**From:** Mike Taddy <mike@taddypropertieservices.com>  
**Sent:** Thursday, September 8, 2022 11:10 AM  
**To:** Paul Braun  
**Cc:** Greg Minikel  
**Subject:** External: Re: 1346 Reed Ave

Mike, if you relocate the driveway to the garage it is supposed to be 50 feet from signalized intersections. The map roughly shows were 50 feet would be.

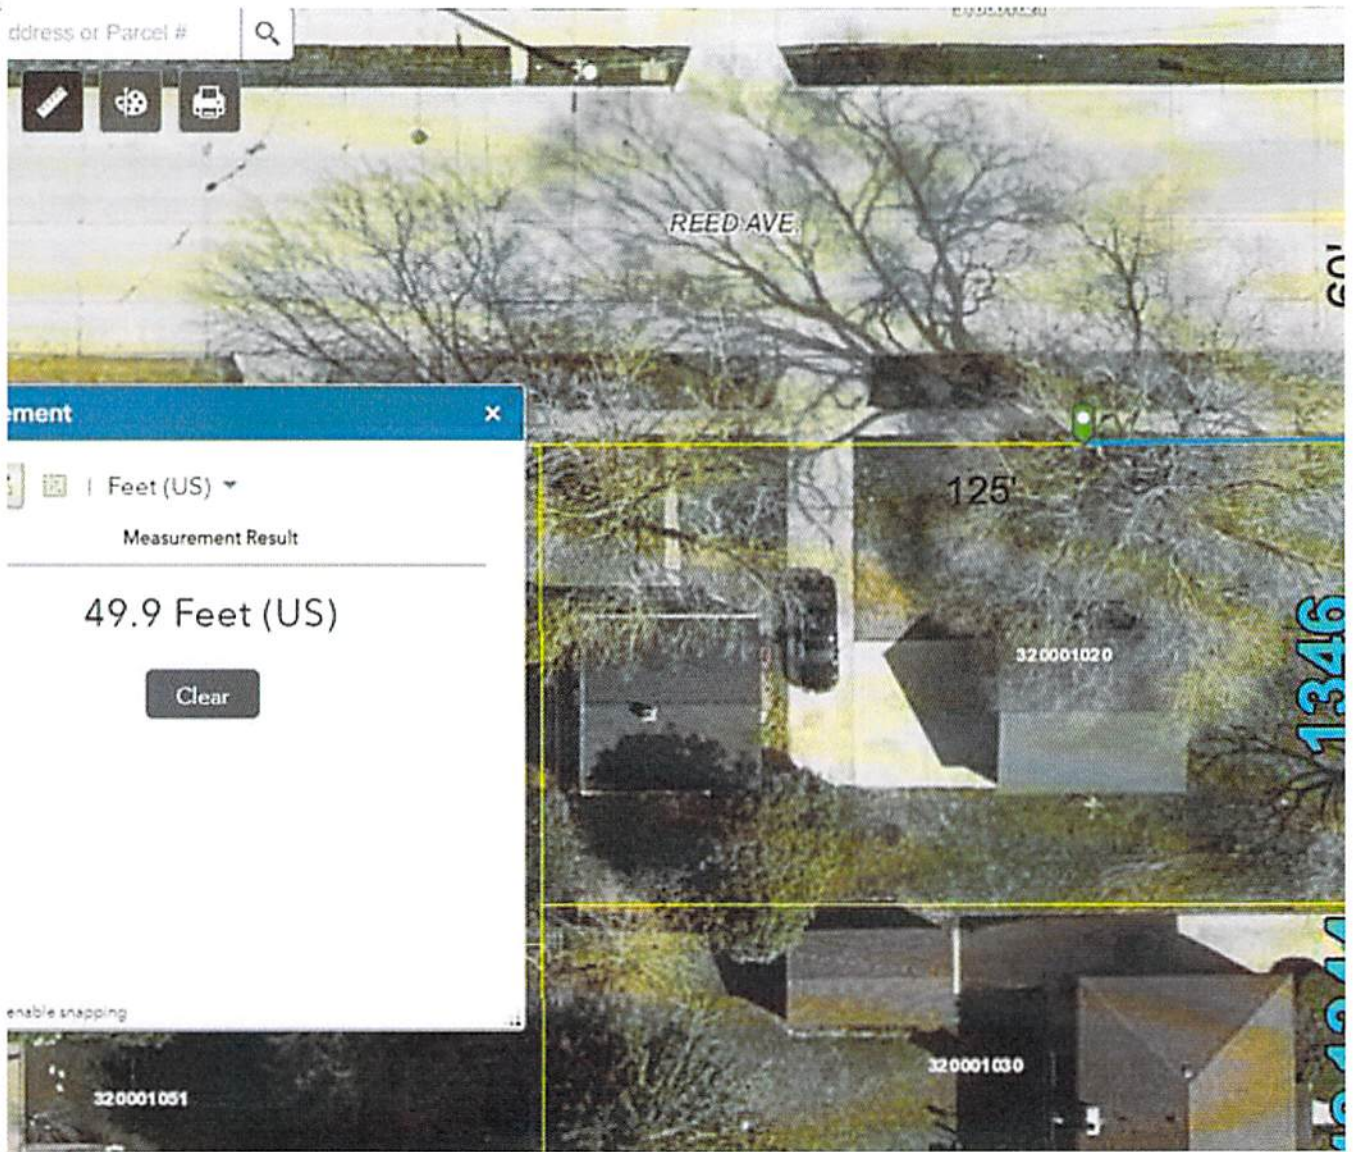
You can work with Greg Minikel in Engineering if you would like to request a waiver to this separation distance.
